SIM900B_SIM300 Differences

April 19,2010

SIM900B VS SIM300

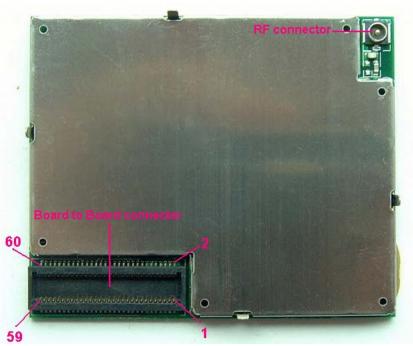
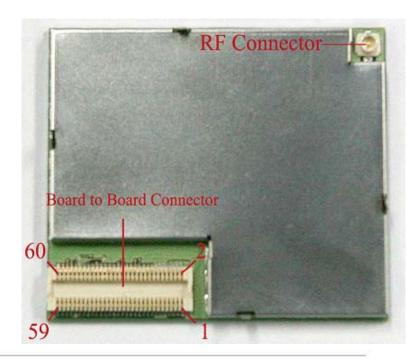
The BTB and RF connectors of SIM300 and SIM900B are different please refer to "SIM900B_HD" and "SIM300_HD" document or contact SIMCom for details
